**RE: BID NO. 2016-4
TRACK AND FIELD IMPROVEMENTS
AT MASUK HIGH SCHOOL
1014 MONROE TURNPIKE
MONROE, CONNECTICUT
MMI #5660-02**

This Addendum No. 1 includes responses to questions received at the May 2, 2016 nonmandatory prebid walk-through, additional written questions submitted to Milone & MacBroom, Inc. (MMI) and/or the Town of Monroe Board of Education, and clarifications and revisions to the Project Manual and Drawings. Modifications are hereby made to the Project Manual dated April 25, 2016 for the above-referenced project.

ADDENDUM NO. 1

SITE ELECTRICAL PLAN
MASUK HIGH SCHOOL
TRACK & FIELD IMPROVEMENTS
1014 MONROE TURNPIKE
MONROE, CONNECTICUT

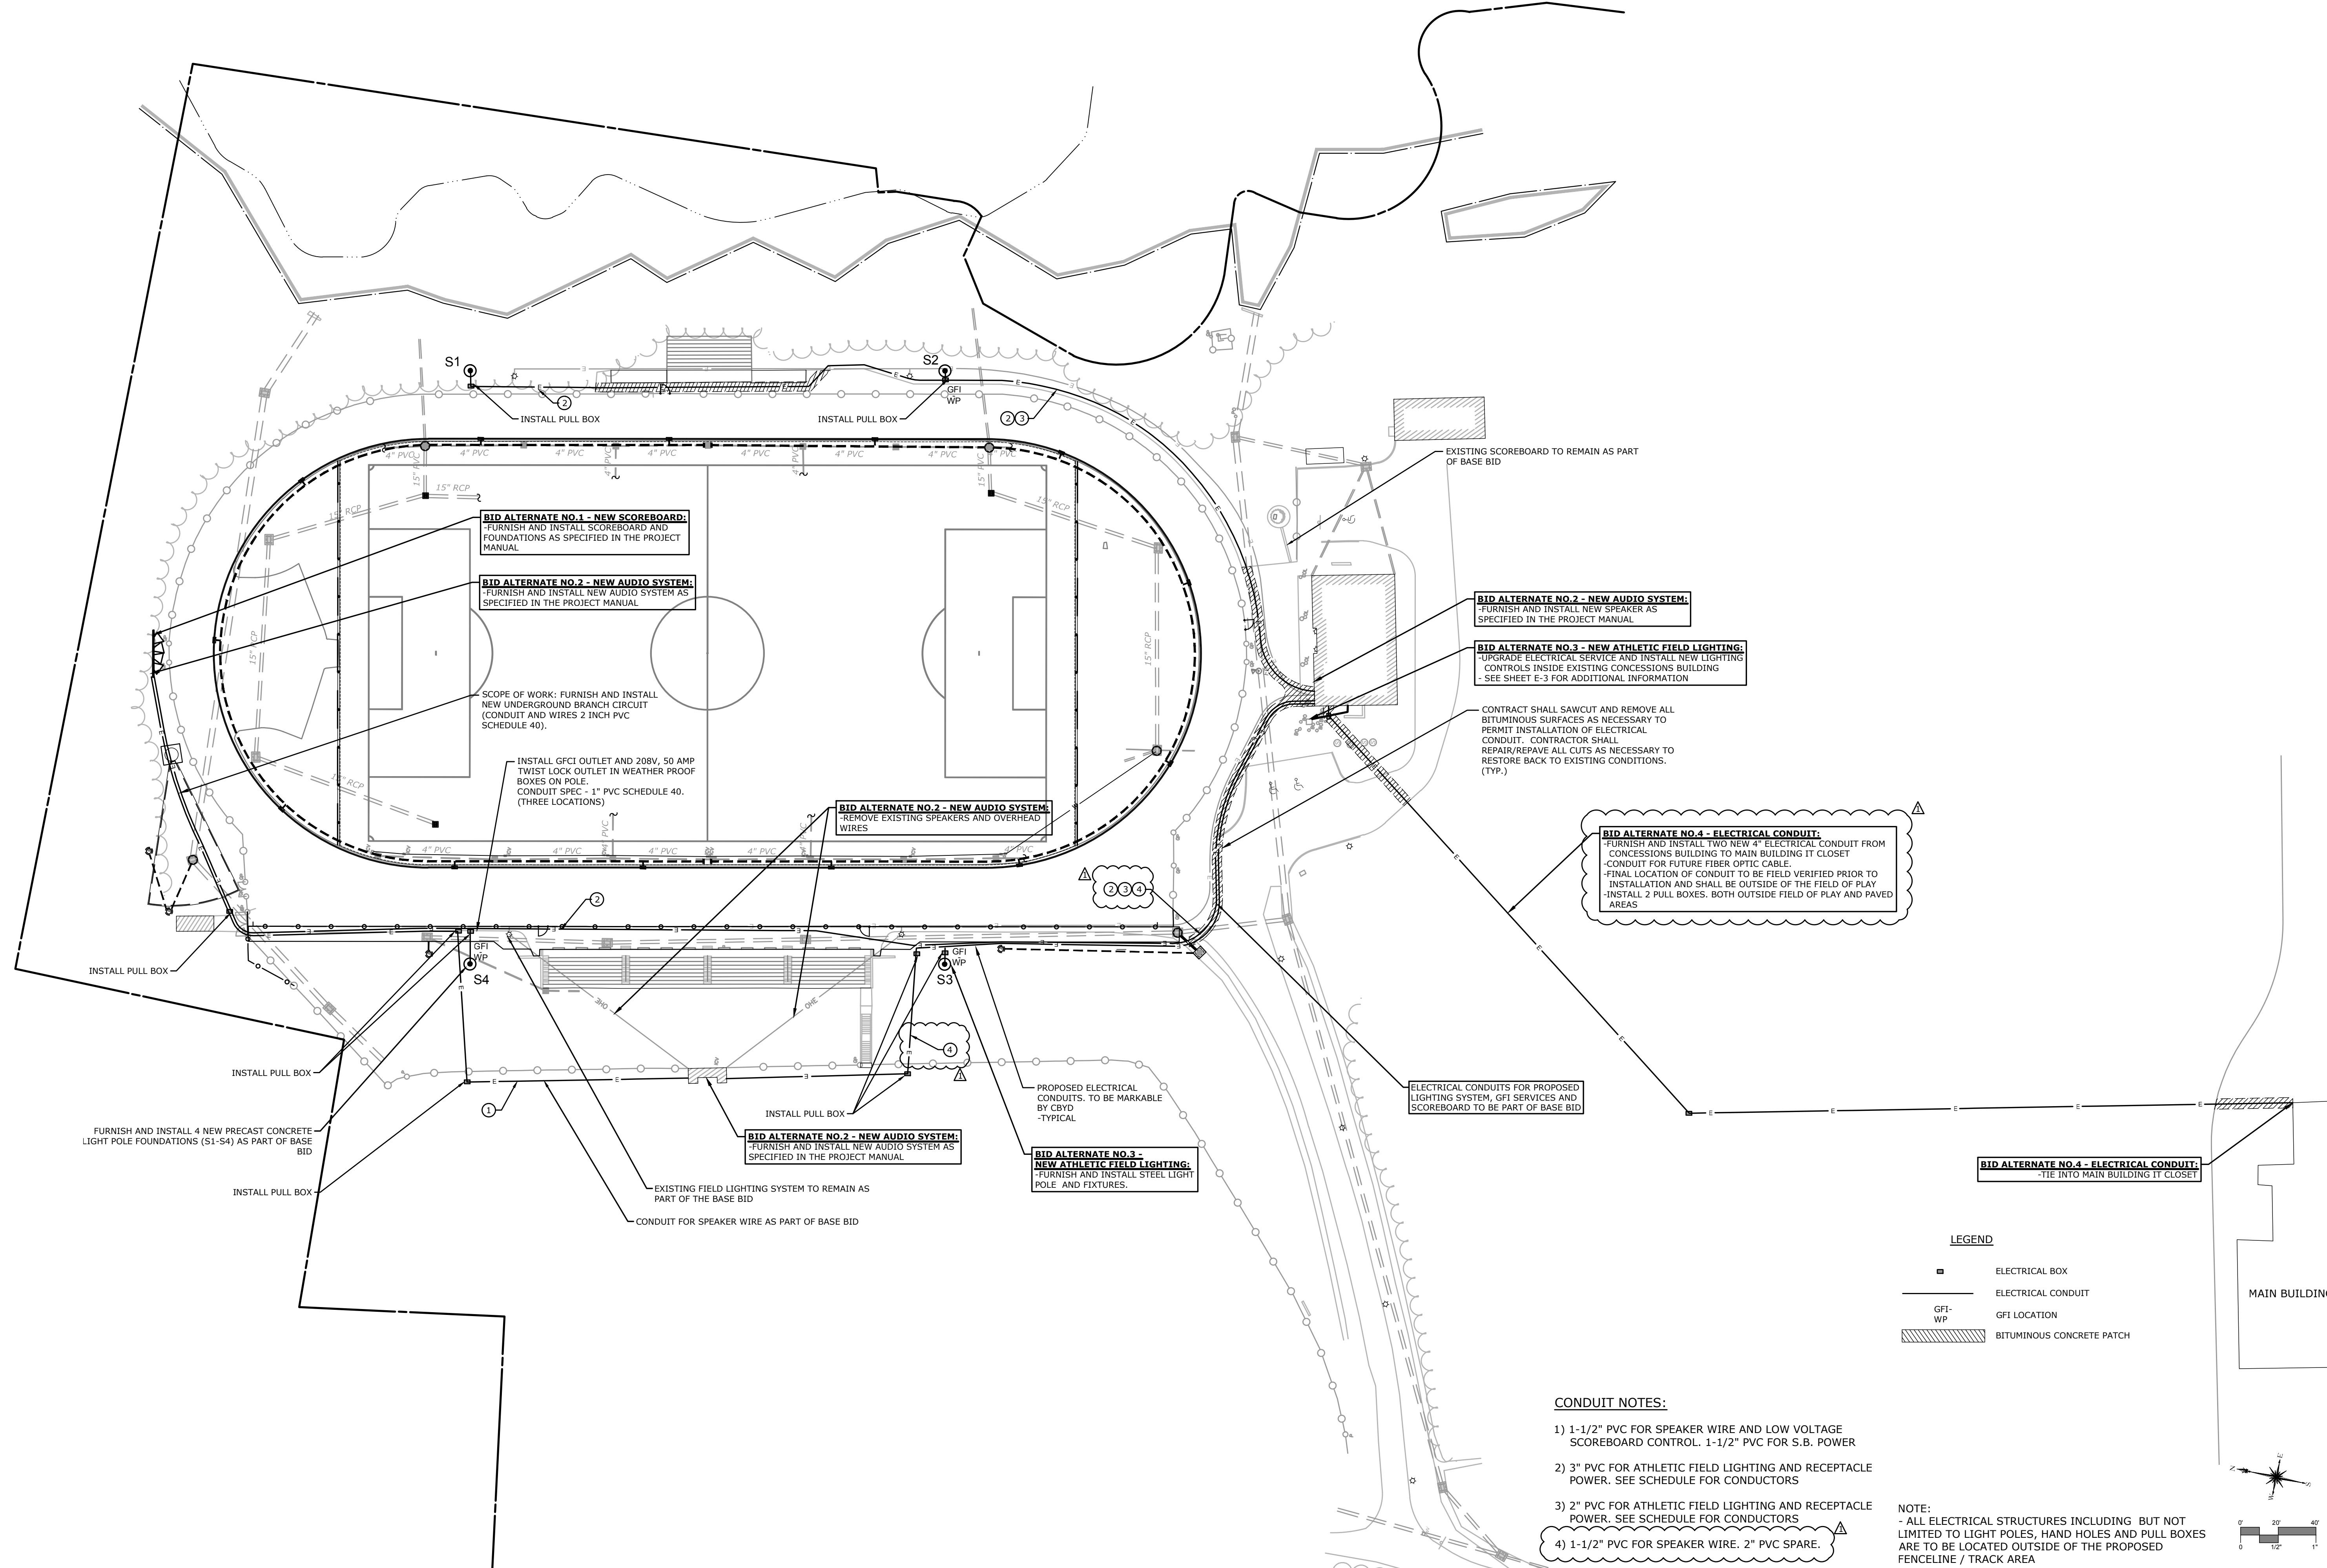
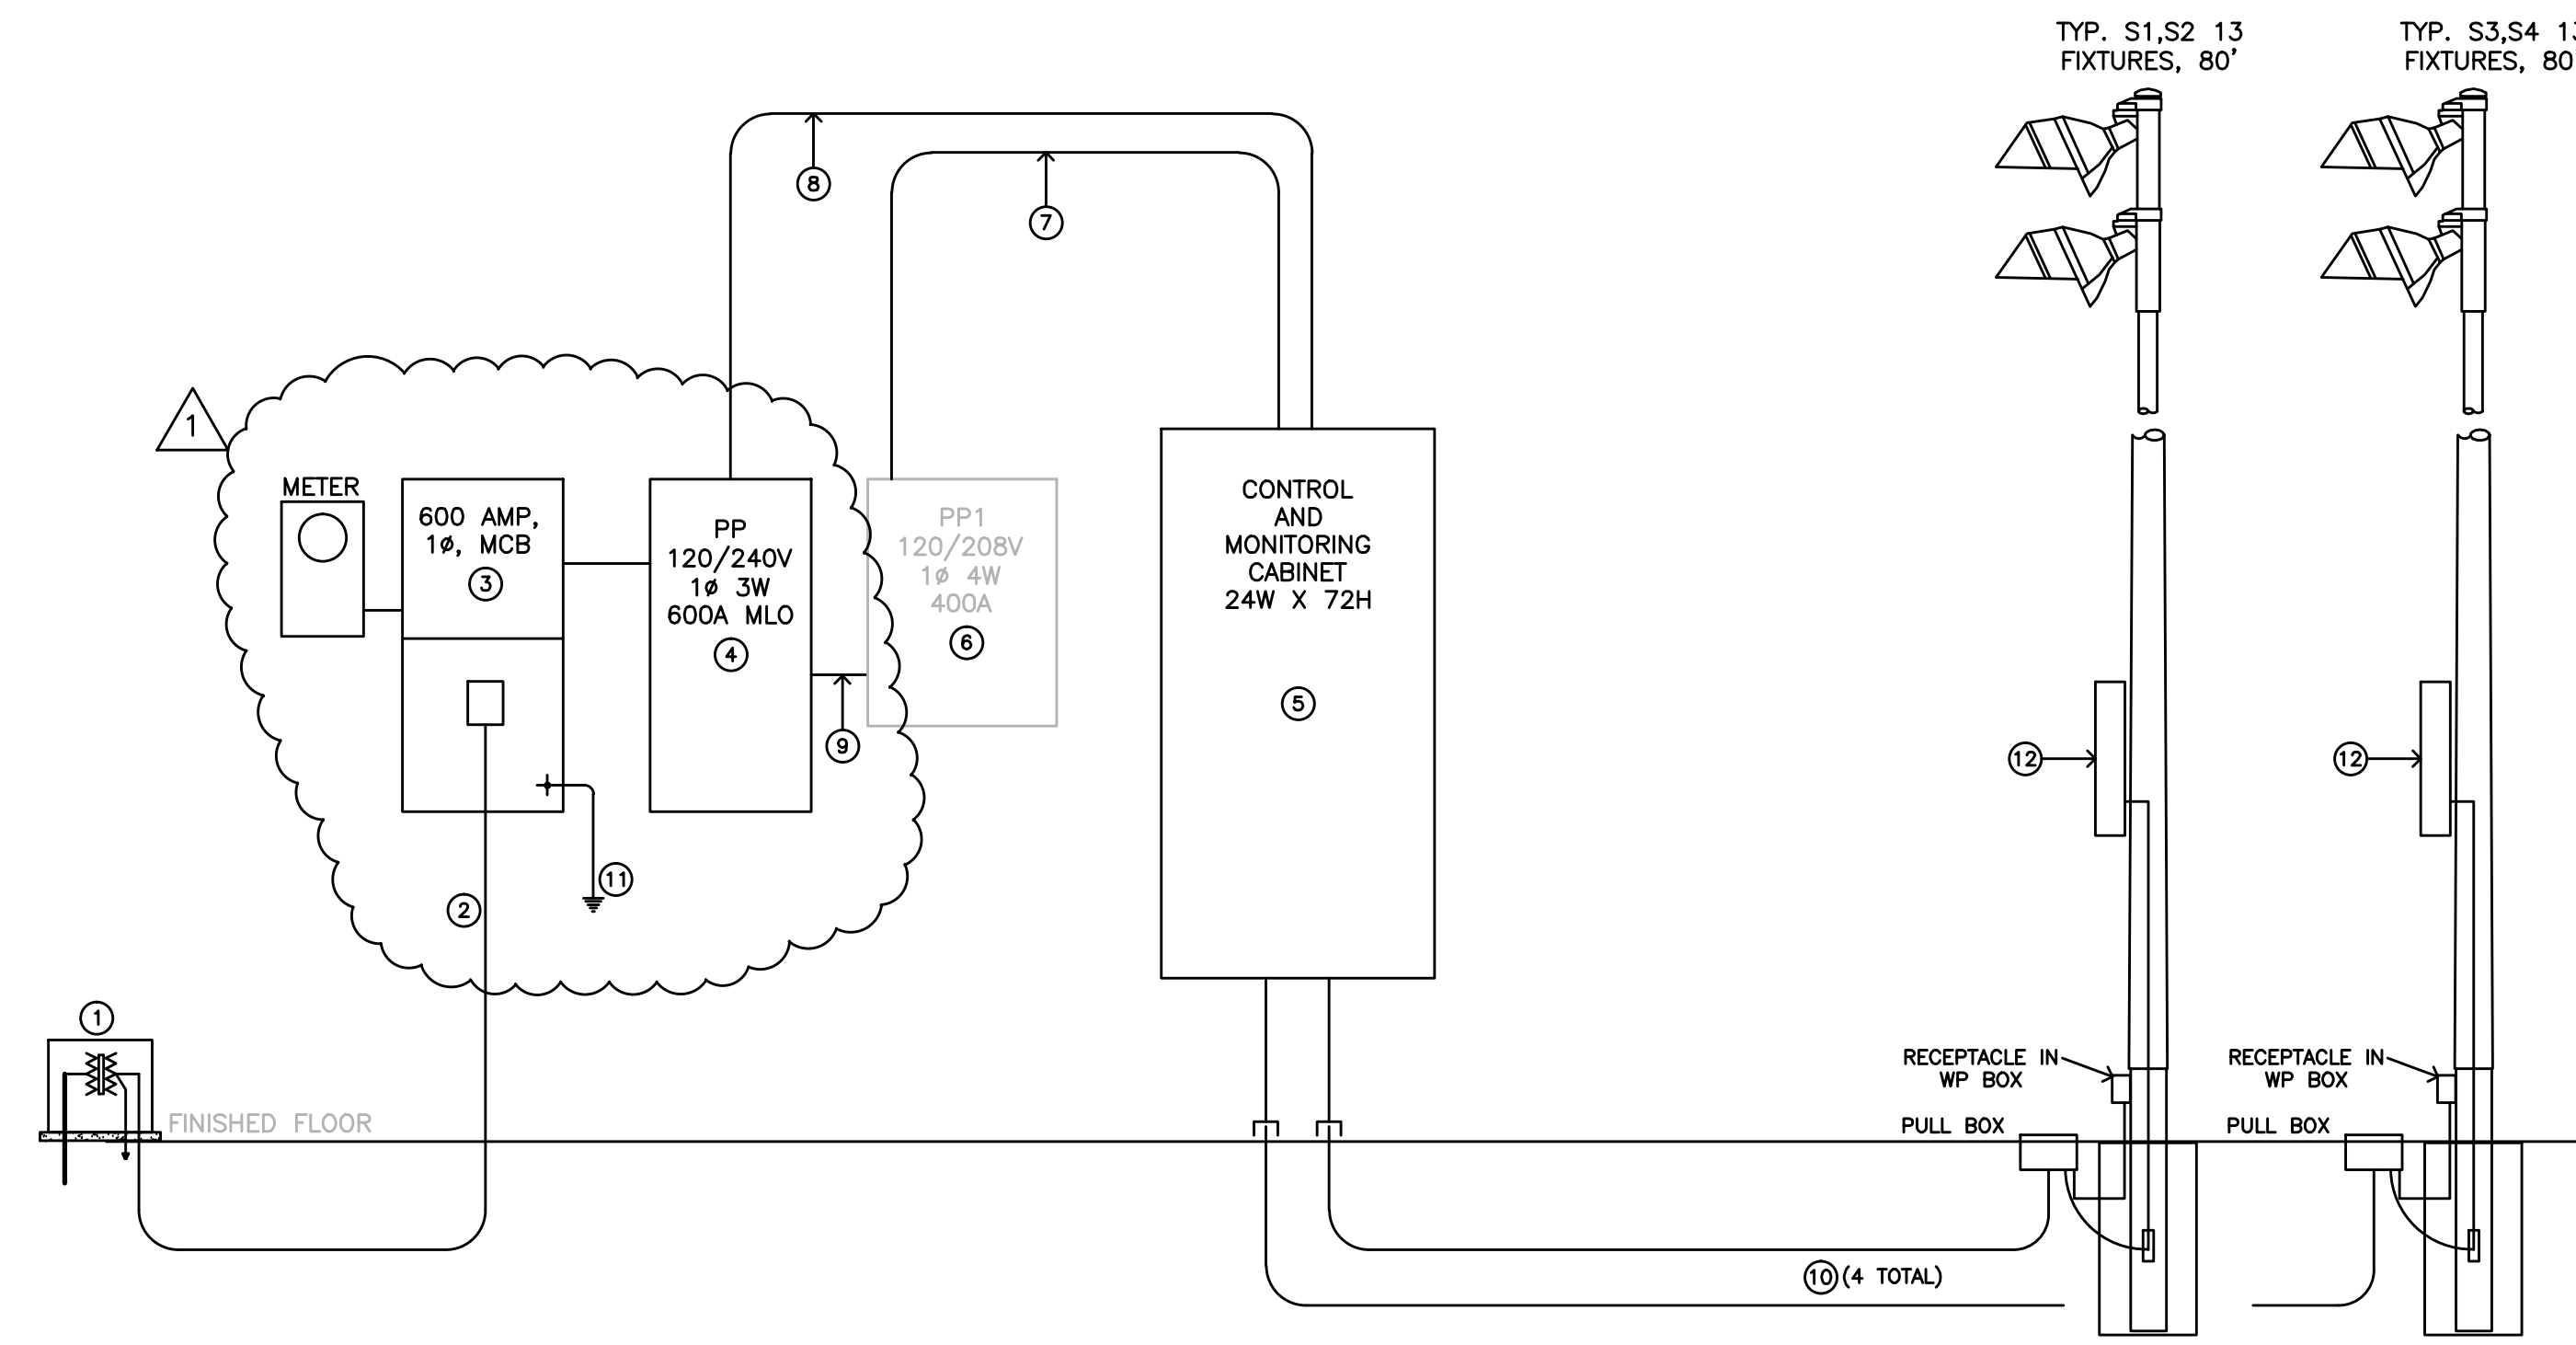
1. The electrical plans have been modified to include some additional conduit and a revised electrical service upgrade design.
2. A temporary storm drainage outlet riser has been detailed for the two existing outlet pipes from the field as depicted in SK-1. This detail should replace the note on the Grading Sheet, which stated, "Block existing outlet from field during construction."
